# Access Compliance Report

## Public Rights-of-Way

Intersection ID: 43584	Main Street: LUKES_DR	Cross Street: PATRIC_ALAN_CT	Location: S
ADA ID: E92E8A19D57F	Ramp Type: PerpDiag	Initial Pass/Fail: Fail	Overall Compliance: No
		Severity Score: 10

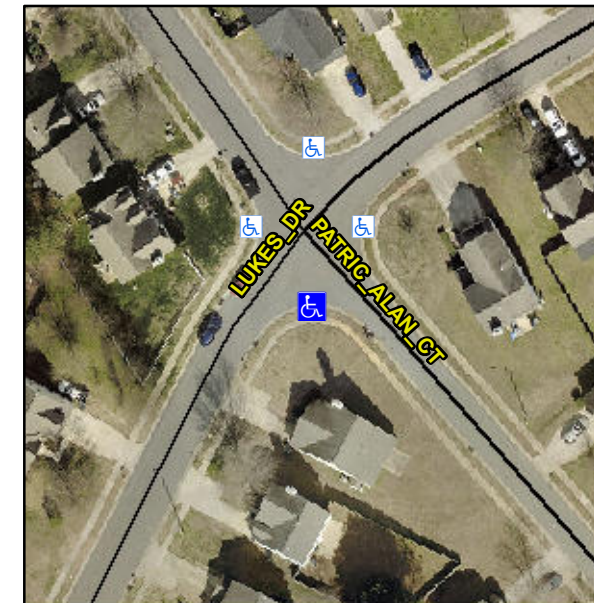
**R304.5.1, R304.5.3**

Compliance	Description	Data	Compliance	Description	Data
N/A	Ramp Length (in)	47.5	Yes	Ramp Slope (%)	7.0
No	Ramp Width (in)	45.5	No	Ramp XSlope (%)	2.1
N/A	Flare Type LT	N/A	N/A	Flare Type RT	N/A
N/A	Flare Slope LT (%)	N/A	N/A	Flare Slope RT (%)	N/A
N/A	Flare Traversable LT?	N/A	N/A	Flare Traversable RT?	N/A
N/A	Landing Length (in)	N/A	N/A	DWS Provided?	N/A
N/A	Landing Width (in)	N/A	N/A	DWS Contrast?	N/A
N/A	Landing Slope (%)	N/A	N/A	DWS Length (in)	N/A
N/A	Landing X Slope (%)	N/A	N/A	DWS Full Width?	N/A
N/A	Landing Curb? (Y/N)	N/A	N/A	DWS Offset (in)	N/A
N/A	Shared Landing?	N/A			
N/A	Gutter Ponding?	N/A	N/A	Gutter Slope (%)	N/A
N/A	Gutter Lip Ht (in)	N/A	N/A	Gutter X Slope (%)	N/A
N/A	Painted X Walk1?	No	N/A	Painted X Walk2?	No
	X Walk 1 Direction	To NE		X Walk 2 Direction	To NW
N/A	X Walk 1 Width (in)	N/A	N/A	X Walk 2 Width (in)	N/A
	X Walk 1 Slope (%)	4.8		X Walk 2 Slope (%)	1.6
	X Walk 1 X Slope (%)	0.5		X Walk 2 X Slope (%)	3.7

**Remove & Replace Curb Ramp With Two New Directional Ramps or Equivalent.**
